SERVICE BULLETIN

APPLICABILITY: 2019-21MY Crosstrek PHEV **NUMBER:** 09-82-23R

SUBJECT: DTC P0452 EVAP System (CPC) Pressure Sensor/Switch Circuit Low **DATE:** 10/02/23

Design Changes to Fuel Tank Assembly & Vent Tubes

1. Resin Tube on the Fuel Tank Assembly (attached directly to the Vent Solenoid)
2. Vent Tube #1
3. Vent Tube #2

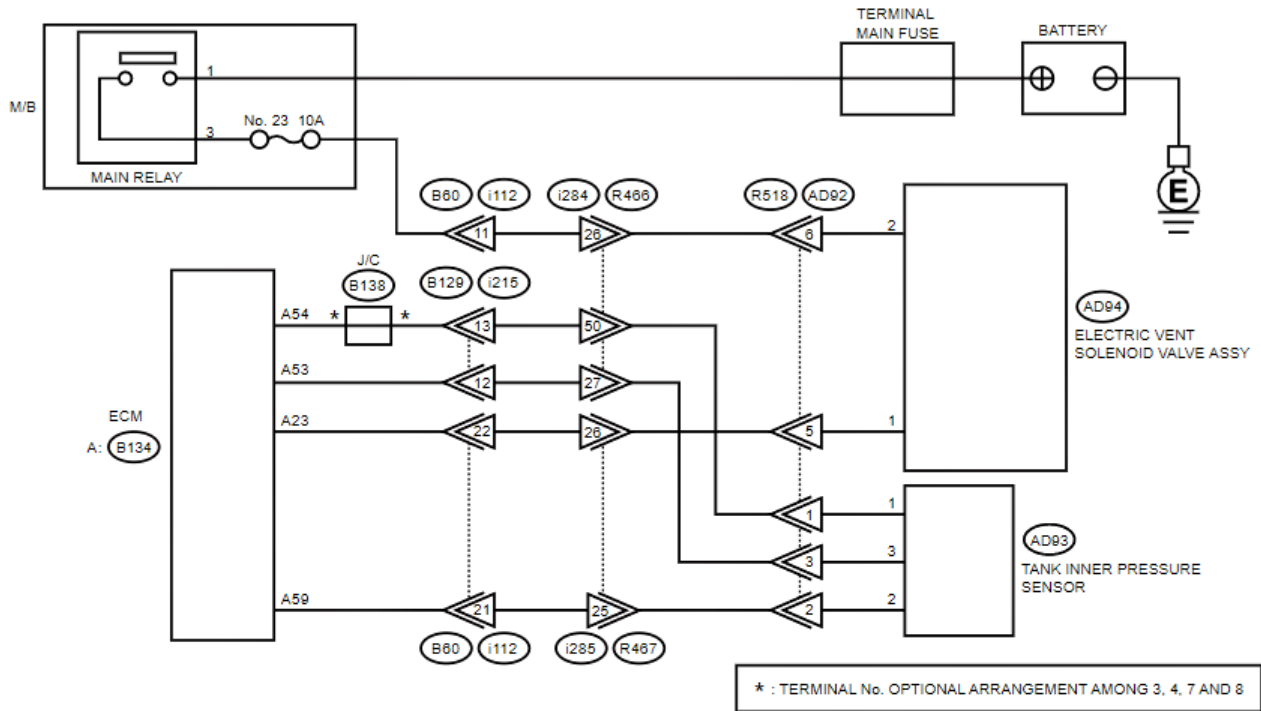
Visually inspect the internal condition of the Evaporative Line connections to the Electronic Vent Solenoid:

If any deposits/build-up is found inside the tube(s), replace all the Vent Tubes and Fuel Tank Assembly.
